**MIDWEST CITY MUNICIPAL AUTHORITY
WATER TREATMENT PLANT
ROOF REPLACEMENT
10701 WATER PLANT RD**

ADDENDUM #1

January 29th, 2025

ROOF SECTIONS 1, 2, 3, and 4

ROOF PLAN
 SCALE 1" = 10'
 0' 5' 10' 20'
 ALL DIMENSIONS TO BE VERIFIED BY THE CONTRACTOR

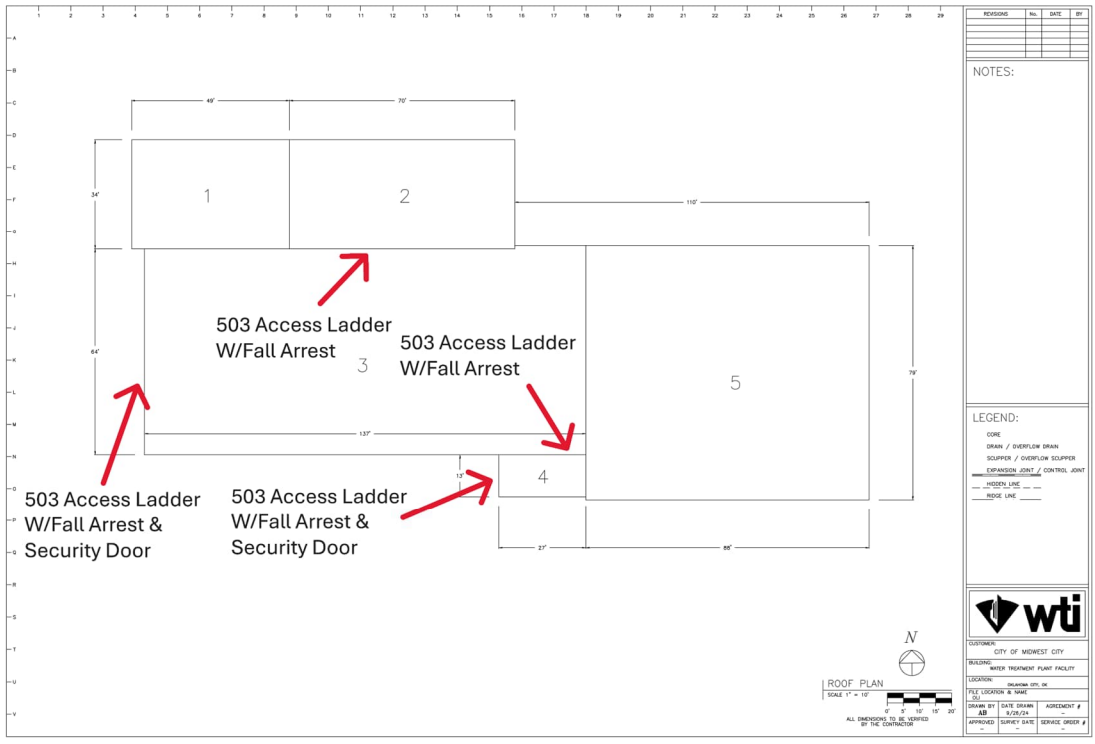
- Roof Section 1: Correction-new galvanized scupper inserts, pre-finished 24-gauge conductor heads, downspouts, with elbows and concrete splash pads to be installed on North and West Perimeter. (Two evenly spaced on North Perimeter, one on West Perimeter.)
- Roof Section 3: On the South Perimeter, install new galvanized scupper inserts, pre-finished 24-gauge conductor heads, downspouts, with elbows and concrete splash pads.
- Roof Section 4: Saw cut a new Reglet joint on the north masonry wall and install new counterflashing with “v” hem. Use lead wedges 8” O.C. Seal with sealant as specified. Tool neatly. On the South Perimeter, install new galvanized scupper inserts, pre-finished 24-gauge conductor heads, downspouts, with elbows and concrete splash pads.

- As directed, where fluorescent paint is utilized on abolished equipment, remove and dispose of appropriately. Install 20-gauge flat metal where necessary and reroof as specified.
- Prefinished 24-gauge metal color will be selected by the owner’s representative.
- Fixed Access Ladders to be included in total base bid. Location of ladders and accessories to be included are indicated below on Roof Plan. All ladders to be budgeted are the 503 Access Ladder manufactured by Okeeffe’s Inc.
